# CITY OF MOUNTAIN VIEW

### STAFF REPORT

##### 5.1 Study Session to Discuss Proposed General Plan and Zoning Map Amendments, Transfer of Development Rights from the Los Altos School District Site, and Planned Community Permit, Development Review Permit, and Heritage Tree Removal Permit to Construct a New 382-Unit Residential Development to Replace One Existing Office Building at 400 Logue Avenue

**Figure 9: Highest Occupiable Level**

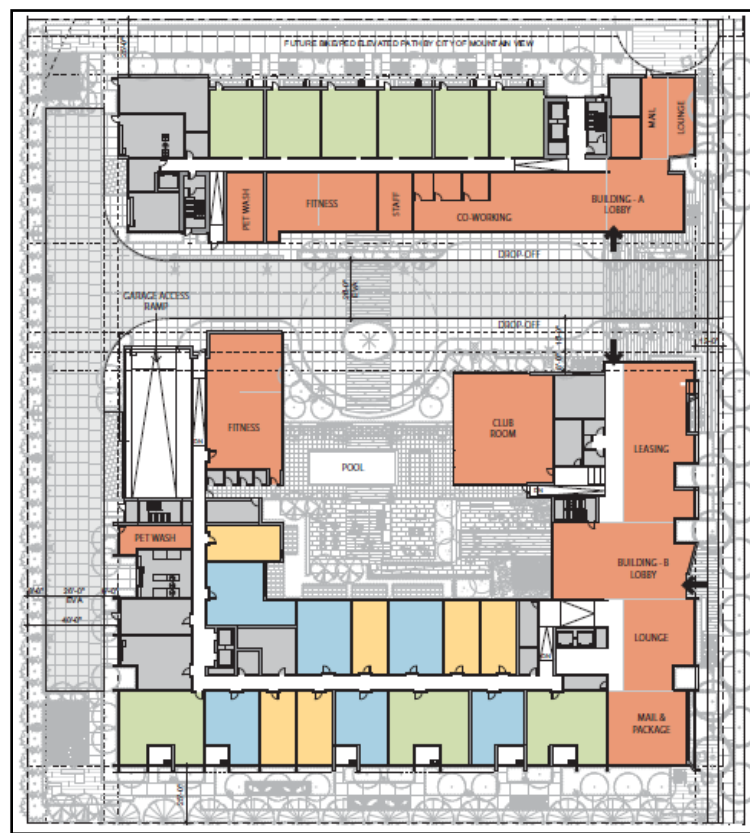
The proposed project currently includes common usable open areas in a few locations, including: a rooftop pool decks Building A and a central courtyard and pool at ground-level of Building B. The project plans indicate these areas result in 11,580 square feet of common usable open area (approximately 30 square feet per unit) in addition to 11,650 square feet of private decks, balconies, and patios (approximately 30 square feet per unit). As currently designed, the total combined open area of 23,230 square feet (or 61 square feet per unit) results in a project

deficit of 22,610 square feet as compared to the 45,840 square feet required by the EWPP.

The applicant has been working with staff to evaluate options to achieve a more compliant open space plan. Staff recommends studying additional rooftop open space locations. Staff also recommends relocating the existing trash collection, loading, and/or parking garage access, which are currently located toward the rear of the site and cause all associated vehicles to traverse the entire length of the on-site service road/EVA. Moving these facilities closer to or along Logue Avenue could allow a significant portion of the on-site roadway to be designed and programmed instead as a joint EVA/open space, similar to the recently approved Prometheus Real Estate Group residential project at 525, 555, and 769 East Evelyn Avenue. While this would place these facilities in more visible locations, staff would work with the applicant on design solutions, and these changes could help the project achieve compliance with the EWPP open-area standards and improve the pedestrian experience throughout the site.
